# DESCRIPTIVE REPORT

| Type of Survey Hydrographic                      |
|--|
| General Locality Yakutat and Disenchantment Bays |

# Descriptive Report to Accompany Hydrographic Survey H10902

Field Number RA-10-11-99 Scale 1:10,000 June 1999 NOAA Ship RAINIER

Illustration 2. Comparison between VBES, SWMB, and SeaBeam

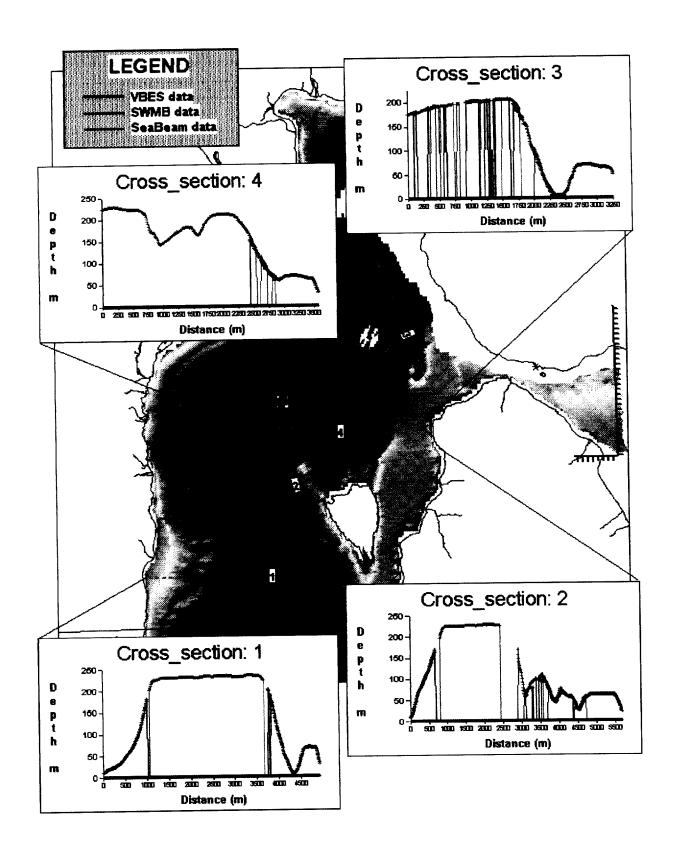
The SeaBeam data showed downsloping at both ends of the swath, despite attempting to minimize sound velocity and tidal influences by eliminating outer beams. It is possible the SeaBeam had difficulty in bottom detecting due to the bottom material of Disenchantment Bay. In areas where there were distinct slopes and formations, the SeaBeam compared well with VBES and SWMB data. Overall, the SeaBeam compared within 1-3 meters of the VBES and Reson data (see Illustration 2 on next page). Conow

The VBES and Reson data compared well, generally within 1-2 meters in regions of low vertical gradients. Larger differences between VBES and Reson occurred in areas of steep relief. These differences between the two methods of surveying are a function of horizontal positioning, beam width, water depth, slope and echo return processing (see Illustration 2). Concur

Illustration 3. Priors surveys covering H10902 survey area.

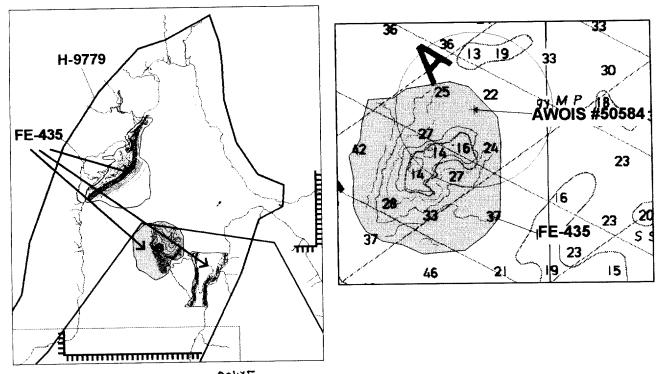
One of the two prior surveys listed in the Project Instructions was mistyped. The prior H-9776 listed is located within Cook Inlet, east of Tuxedni Bay. The correct prior for this survey area is H-9779. Correct Table 2 and Illustration 3 (on page 10) shows the two prior surveys conducted in the H10902 area:

Illustration 5. Location of AWOIS 50584 on Chart 16760

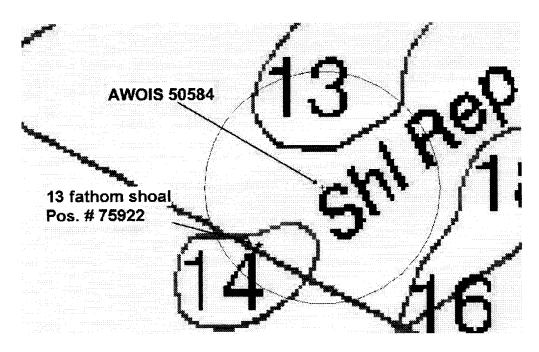
The Hydrographer recommends removing the "Shoal Reported 1990 PA" on Chart 16760, and chart present survey soundings on both chart 16760 and 16761. Concur
